Project	IEEE 802.16 Broadband Wireless Access Working Group < http://ieee802.org/16 >	
Title	Problems with Initial Ranging in OFDM PHY and a Solution	
Date Submitted	2005-01-26	
Source(s)	David A Castelow, Gavin Meakes, Eyal Verbin Airspan Communications, Cambridge House, Oxford Road, Uxbridge, UK Joël Demarty, Ambroise Popper SEQUANS Communications 101-103 bld Mc Donald, 75019 Paris, France Lei Wang Cygnus Multimedia Communications	Voice: +44 1895 467281 Fax: +44 1895 467202 mailto:dcastelow@airspan.com Voice: +33 1 44 89 48 07 mailto:joel@sequans.com mailto:lwang@cygnuscom.com
Re:	Supporting document for Comment to 802.16maint.	
Abstract	Changes required in order enabling good operation of 802.16 systems.	
Purpose	The document is intended for consideration within the comments resolution process.	
Notice	This document has been prepared to assist IEEE 802.16. It is offered as a basis for discussion and is not binding on the contributing individual(s) or organization(s). The material in this document is subject to change in form and content after further study. The contributor(s) reserve(s) the right to add, amend or withdraw material contained herein.

Problems with Initial Ranging

Figure 60 – Initial Ranging – SS (part 1)

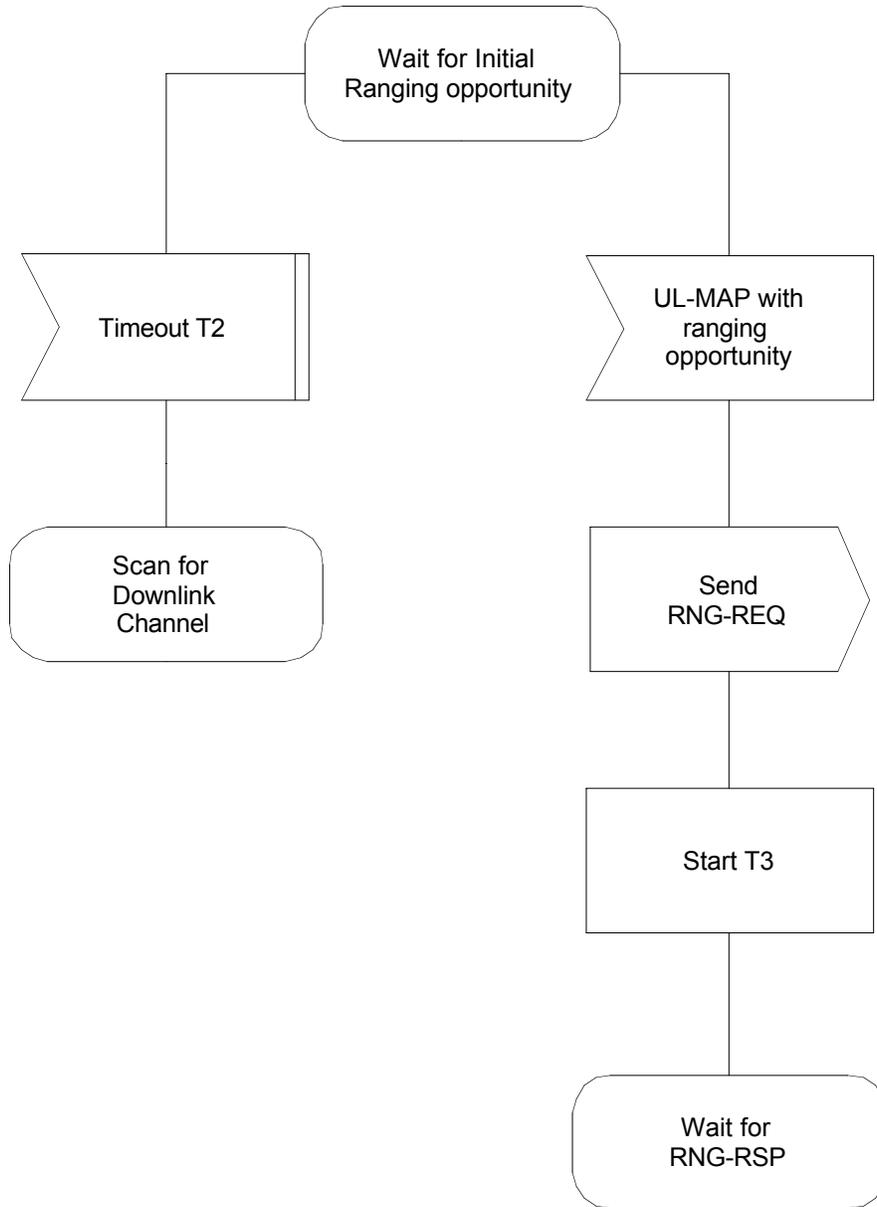
Test "Time to increase power?" does not seem to have a timer associated with it. It is in conflict with the text at [2, page 178, line 53 and page 179, line 6]. In these lines the power is required to be increased at each step. However, the change in power is not defined in the standard, and so the power step could be zero or changed dynamically. We suggest replacing the power step with an instruction to adjust the power.

When the SS fails to range properly on a given downlink channel, the spec (clauses) instructs the SS to mark the channel as unusable and start a timer T19 during which the channel remains unusable. This timer is SS specific (see section 10.1) and has no lower bound defined. An SS can implement this timer as 0.

We believe this timer T19 belongs to the scanning algorithm which is implementation dependent. As a consequence, this timer should be removed from the specification.

[Replace Figure 60 with the following figure:]

NOTE 1 — Timeout T3 may occur because the RNG-REQs from multiple SSs collided. To avoid these modems repeating the loop in lockstep, a random backoff is required. This is a backoff over the ranging window specified in the UCDDT3 timeouts can also occur during multi-channel operation.

NOTE 2 — On a system with multiple uplink channels, the SS must attempt initial ranging on every suitable uplink channel before marking the downlink channel unusable and moving to the next available downlink channel.

Figure 210a – Subchannelized Initial Ranging – SS (part 1a)

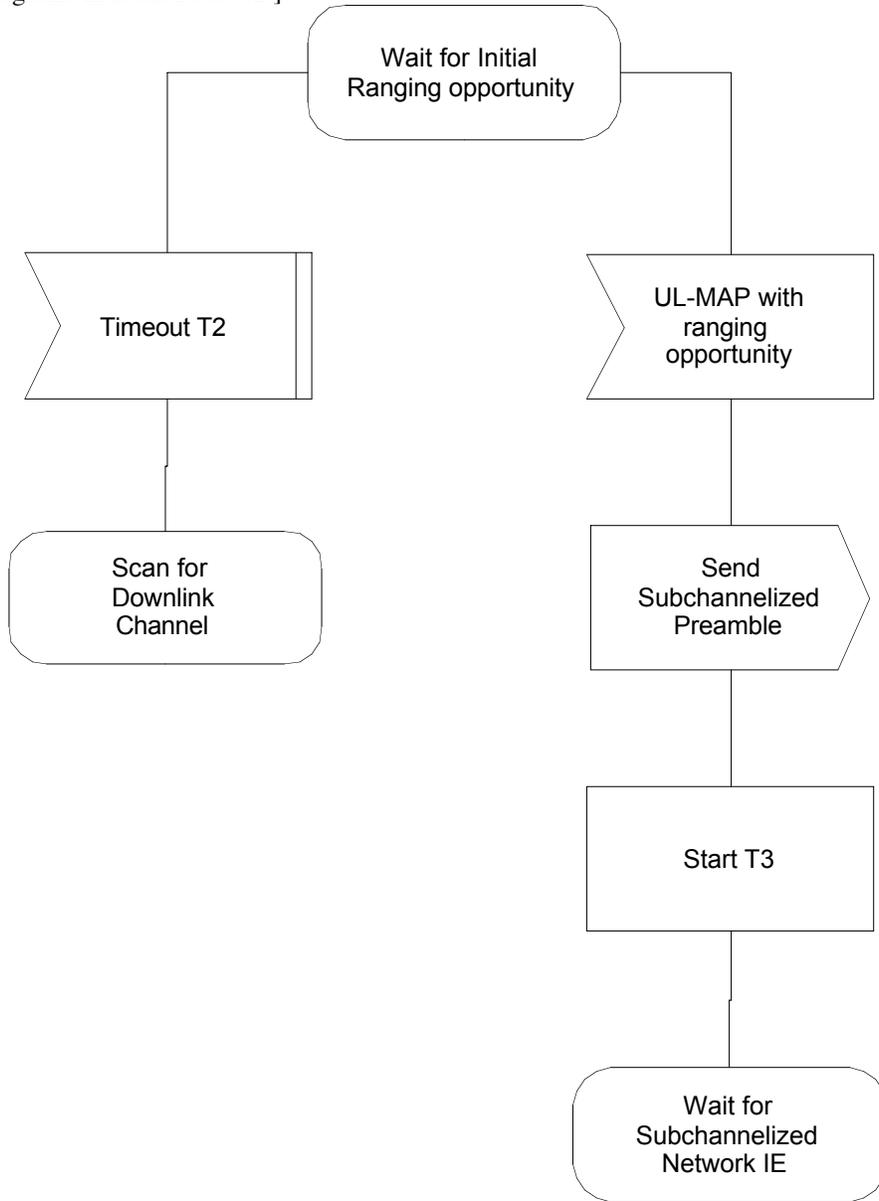
In section 8.3.7.2 [2, page 479] there are a number of statements regarding the mechanism a sub-channel capable SS is to adopt during initial ranging. However, there are no SDL diagrams showing the actions of either the BS or the SS during these phases. This requires modifications in section 6.3.9.5 [2, page 177 forward] and changes to the diagrams in figures 61, 62. In addition, the process described in 8.3.7.2 is unclear as to whether it is a single-shot subchannelized initial ranging, or can be attempted multiple times. No timers are defined indicating whether this should be done once or many times., nor is it clear when an SS might change from normal to subchannelized initial ranging. It therefore does not make sense for the SS to be constrained by a process. In section 8.3.7.2 it is suggested that an SS may switch to Subchannelized IR when the Ptx is beyond its maximum supported power. This means that an SS may start subchannelized initial ranging at any attempt. Moreover, the subchannelized IR capable BS must be prepared to receive SCIR at any time. As it is unclear how to specify the change, we propose to remove all constraints on when an SS may switch to subchannelized IR.

Another problem in the subchannelized initial ranging is that the text specifies that SS shall attempt subchannelization IR if the BS supports that. However, there is a problem, because the SS does not know at this stage whether the BS actually is capable of

subchannelization. This capability is currently negotiated only at the SBC stage. One solution is that the BS shall report the subchannelized IR capability in the UCD message, as indicated in the text changes that follow.

~~SSs that compute their $P_{TX_IR_max}$ to exceed their maximum power level and SSs which have attempted initial ranging with the maximum power level using RNG-REQ may, if the BS supports subchannelization, an SS may attempt initial ranging in an initial ranging slot using the following burst format, as indicated in Figure 210a and Figure 210b:~~

[Include the following diagrams in section 8.3.7.2:]
